Access Compliance Report

Public Rights-of-Way

(Curb Ramps)

Intersection ID: 31591	Main Street: HUGUE_WY	Cross Street: BLUE_BRIDGE_CT	Location: NE
ADA ID: F4162E8C574E	Ramp Type: PerpDiag	Initial Pass/Fail: Fail	Overall Compliance: No
Severity Score: 8.75			
Codes/Mitigation Info/Possible Solution		Field Measurements/Component Compliance

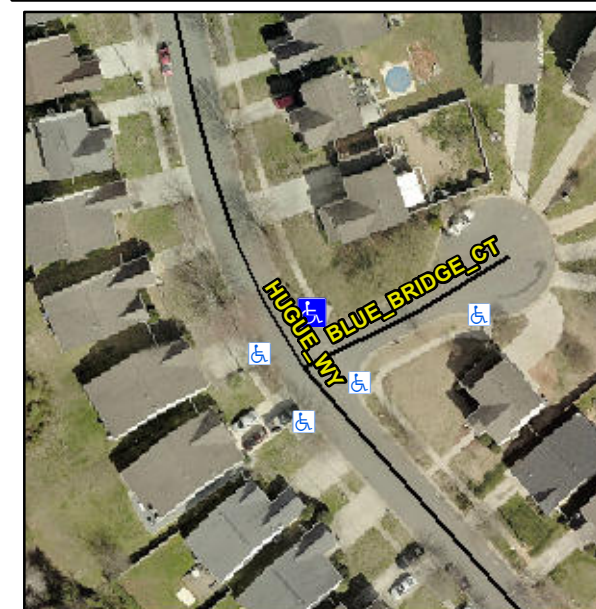
R304.5.1

Compliance	Description	Data	Compliance	Description	Data
N/A	Ramp Length (in)	81.0	Yes	Ramp Slope (%)	5.6
No	Ramp Width (in)	47.0	Yes	Ramp XSlope (%)	0.5
N/A	Flare Type LT	N/A	N/A	Flare Type RT	N/A
N/A	Flare Slope LT (%)	N/A	N/A	Flare Slope RT (%)	N/A
N/A	Flare Traversable LT?	N/A	N/A	Flare Traversable RT?	N/A
N/A	Landing Length (in)	N/A	N/A	DWS Provided?	N/A
N/A	Landing Width (in)	N/A	N/A	DWS Contrast?	N/A
N/A	Landing Slope (%)	N/A	N/A	DWS Length (in)	N/A
N/A	Landing X Slope (%)	N/A	N/A	DWS Full Width?	N/A
N/A	Landing Curb? (Y/N)	N/A	N/A	DWS Offset (in)	N/A
N/A	Shared Landing?	N/A			
N/A	Gutter Ponding?	N/A	N/A	Gutter Slope (%)	N/A
N/A	Gutter Lip Ht (in)	N/A	N/A	Gutter X Slope (%)	N/A
N/A	Painted X Walk1?	No	N/A	Painted X Walk2?	No
	X Walk 1 Direction	To SW		X Walk 2 Direction	To SE
N/A	X Walk 1 Width (in)	N/A	N/A	X Walk 2 Width (in)	N/A
	X Walk 1 Slope (%)	0.6		X Walk 2 Slope (%)	0.9
	X Walk 1 X Slope (%)	1.2		X Walk 2 X Slope (%)	2.2

Remove & Replace Curb Ramp With Two New Directional Ramps or Equivalent.
